VSR-TSB-032

NHTSA Campaign Number: 21V-482

Subject: ABS System Fuses

Models Affected: Oshkosh S-Series Front Discharge Mixer

Figure 2

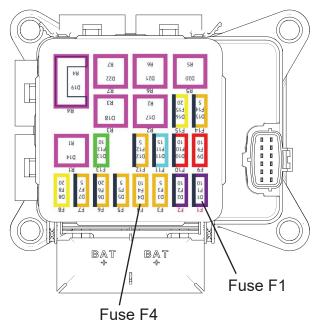
A concern affecting safety exists in some Oshkosh S-Series Front Discharge Mixers. Incorrectly sized ABS system fuses were installed in the rear power distribution module. The ABS system manufacturer is suggesting the 10 amp fuses be replaced with 15 amp fuses for correct modulation of all axles during an active ABS stopping event.

- 4. Remove engine fuse panel cover.
- 5. Remove the 10 amp fuses at position F1 and F4, see Figure 2.
- 6. Install the 15 amp fuses supplied at position F1 and F4, see Figure 2.

Figure 3

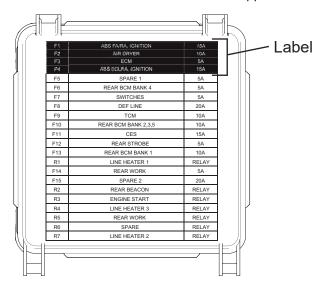
7. Install the fuse identification label supplied on the engine fuse panel cover, see Figure 3.
